LAKE HAVASU CITY, ARIZONA
ADMINISTRATIVE SERVICES DEPARTMENT
◆ PROCUREMENT ◆

INVITATION TO BID
NORTH HAVASU ADDITIONAL TANK & DISTRIBUTION LINE
PROJECT NO. B26-PW-108031-500784
ADDENDUM NO. 1
DATE: APRIL 8, 2026

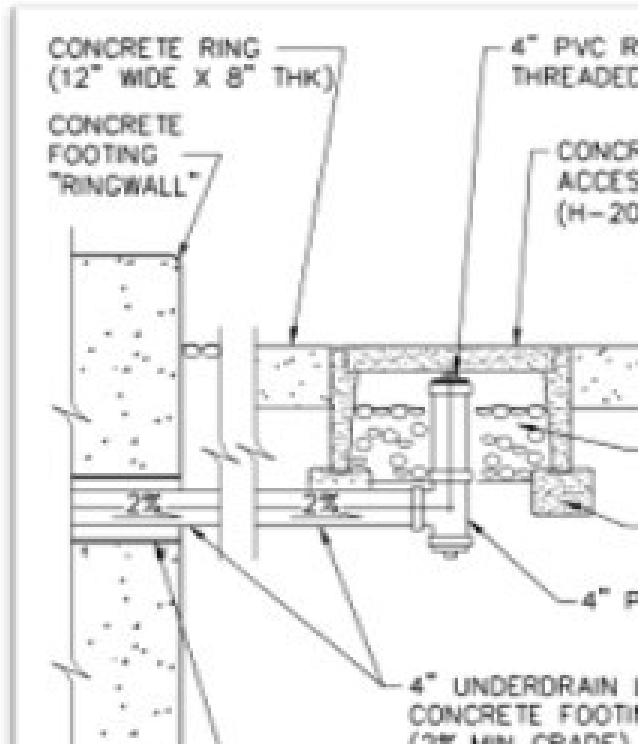
Question 3: *Sheet C-6 calls out two Drain Inspection locations. I cannot find a detail for a Drain Inspection in the drawings. Please provide a detail for the Drain Inspection. Note that one of the Drain Inspection locations is called out as a Sample Station. Please clarify.*

Answer 3: Underdrain Inspection detail has been added to this Addendum. Noted, referenced Sample Station is erroneously labeled and should be a Drain Inspection.
